Re: Toronto Hydro-Electric System Limited 2020-2024 Custom Price Cap Index (PCI) Application
AMPCO Interrogatories
Board File No. EB-2018-0165

AMPCO Interrogatories

Figure 3: Percentage of Assets Past Useful Life

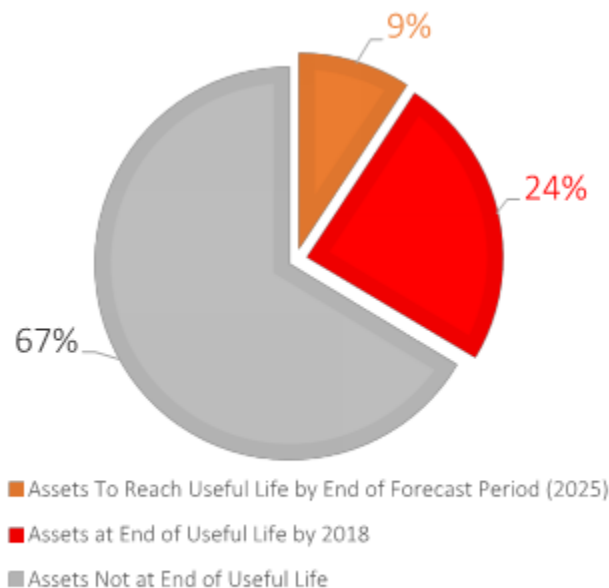
- Please provide the calculation that underpins the percentages in Figure 3.
- Please provide a pie chart that shows the Percentage of Assets with Health Index Scores of H14 and HI5 by 2018; Percentage of Assets with Health Index Scores of H14 and HI5 at the end of Forecast Period (2025); and Percentage of Assets that do not have a Health Index Score of H14 or HI5.
- Please provide the calculation that underpins part b).
